Transport Engineering Response

RE: 241,243&249 Bridge Street, Newtown – Proposed Child care development

Colliers International Engineering & Design (TTMC) Pty Ltd has been engaged to provide a response to the traffic and transport-related items outlined in an Information Request (IR) letter (dated 3rd July 2026) issued by Toowoomba Regional Council ('Council') as part of a DA submission for a proposed child care development at 241,243&249 Bridge Street in Newtown (Application Reference: MCUI/2026/5077).

Figure 1: Proposed Parking Bay Allocation

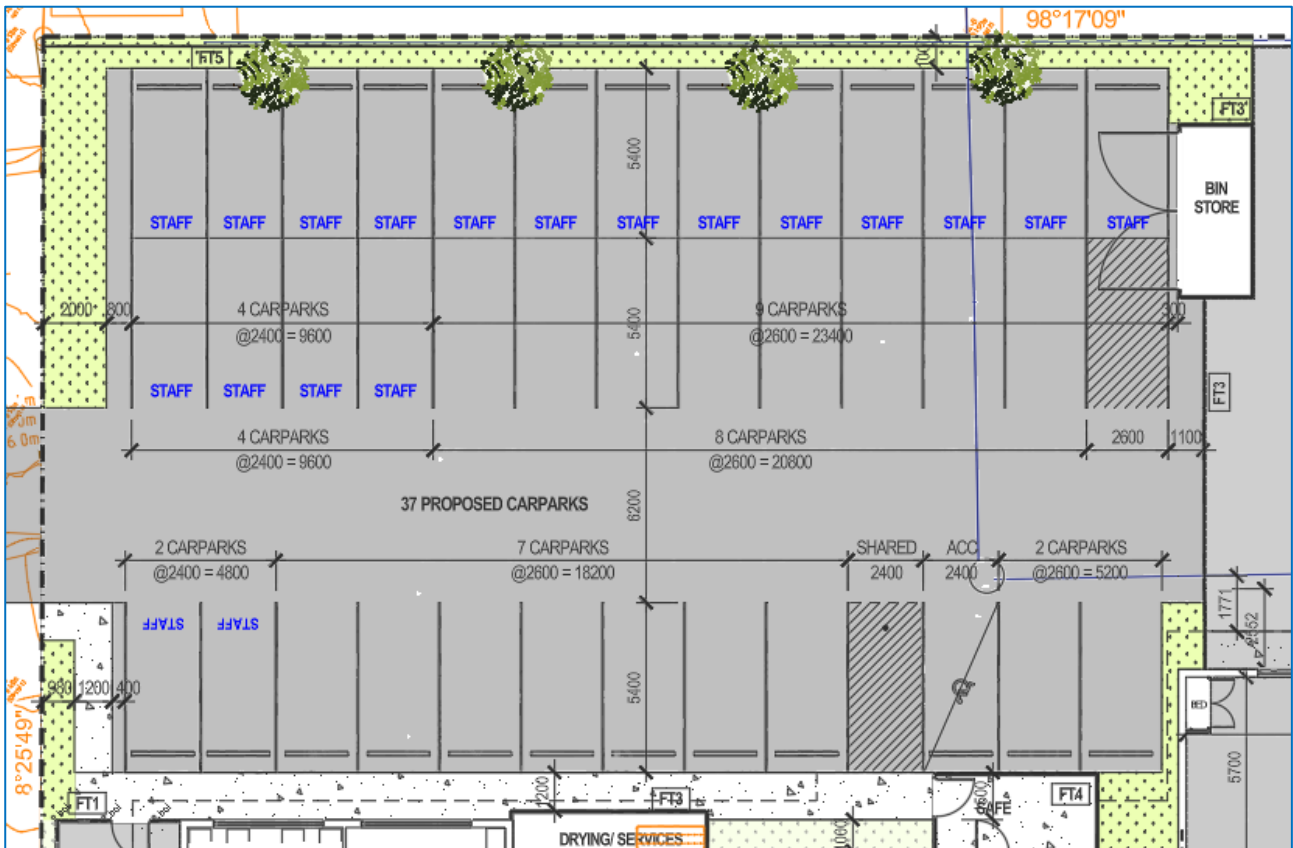
Issue: Visitor Tandem Parking Spaces

The proposed development is subject to the Performance Outcomes outlined in the Transport, Access and Parking Code. The information provided has not satisfactorily demonstrated that these requirements will be achieved. In particular, the proposed use of tandem car parking configurations for visitor spaces is not preferred. Visitor parking must remain highly accessible and unobstructed. Tandem layouts reduce convenience and create operational complexities such as key exchanges, and inevitably lead to vehicles blocking each other. This operational restriction frequently results in visitor parking overflowing onto the public street network, creating localised traffic and safety hazards. The local street network is constrained for additional parking.

Provide an updated site plan to completely remove the tandem spaces for visitors car parking. All proposed visitor car parking spaces must be redesigned as independently accessible, single-use car parks that do not rely on the movement of any other vehicle for ingress or egress. This design revision is required to ensure that visitor parking remains functional, unobstructed, and readily available to members of the public at all times, without causing internal traffic conflicts.

A markup of the proposed parking bay allocation is illustrated in the figure below (in blue), with any unmarked bays expected to serve visitors.

- Both front and rear bays allocated for 'Staff' parking only; **or**
- Front bays allocated for 'STAFF' and rear bays (directly adjacent to the aisle) to be unmarked to allow for 'Visitor' parking.

As such, a staff vehicle parked within the tandem arrangement will not obstruct access to/from the visitor bays, given that these bays are located directly adjacent to the aisle. On this basis, the proposed visitor spaces achieve independent and unobstructed access and therefore are considered acceptable.

It is noted that line marking will be provided for each bay, as indicated in the figure above (in blue), to alert drivers of the proposed parking allocation and can be incorporated as part of the detailed design stage.

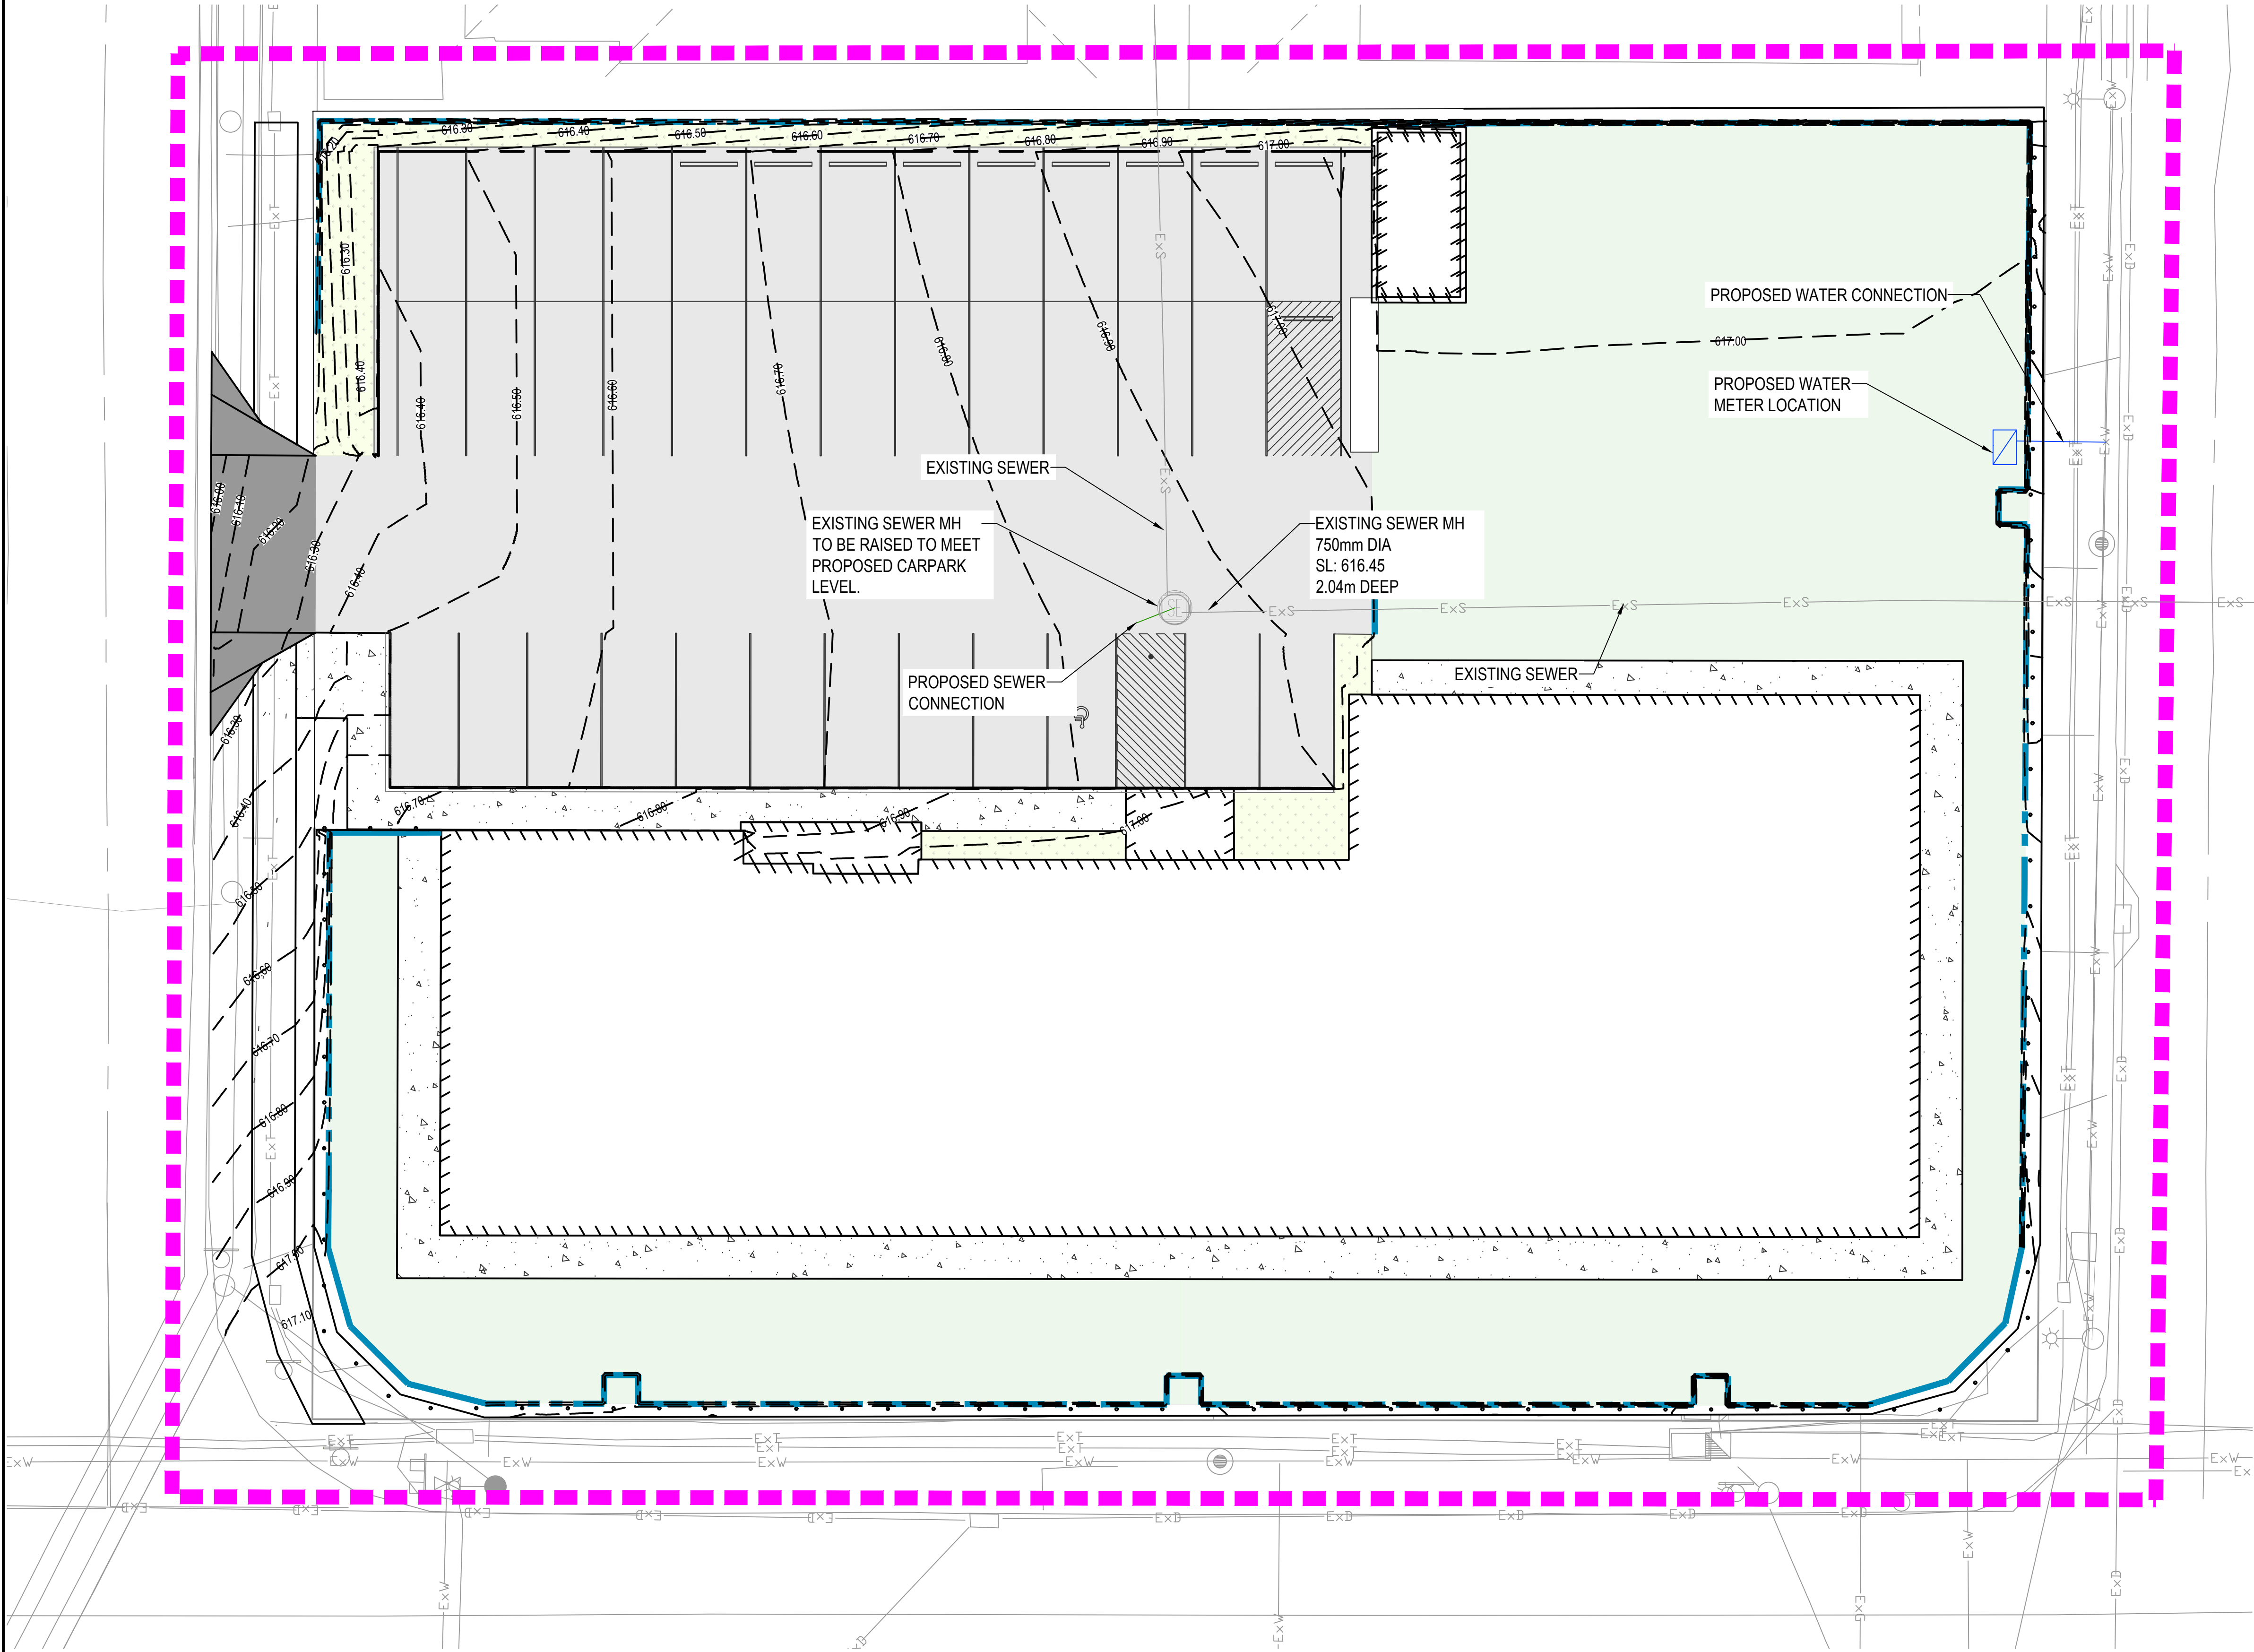
Issue: Footpath and Road Dedication

- Provide an amended plan with a 1.5m footpath along Hillview Avenue and Brim Street connecting to existing footpath at Bridge Street.*
- Provide 1.5m road dedication along Hillview Avenue.*
- Provide road dedication along the Brim Street frontage at a width of 5.5 m. Alternatively, provide a comprehensive engineering justification explaining why 5.5 meters road reserve width for Brim Street cannot be considered necessary or achievable for this development.*

Please refer to the revised Civil engineering drawings in **Attachment A** (prepared by RECOR) demonstrating that a 1.5m wide footpath can be achieved within the existing verge width along Hillview Avenue, including a connection to the public footpath on Bridge Street.

Access to the site is solely provided via Hillview Avenue. A 1.5m wide footpath is therefore proposed along the frontage of the site and will connect to the existing footpath on Bridge Street. As detailed within the civil engineering plans provided in **Attachment A**, the proposed footpath can be fully contained within the existing verge width. The provision of an additional 1.5m land dedication is therefore not considered necessary given that:
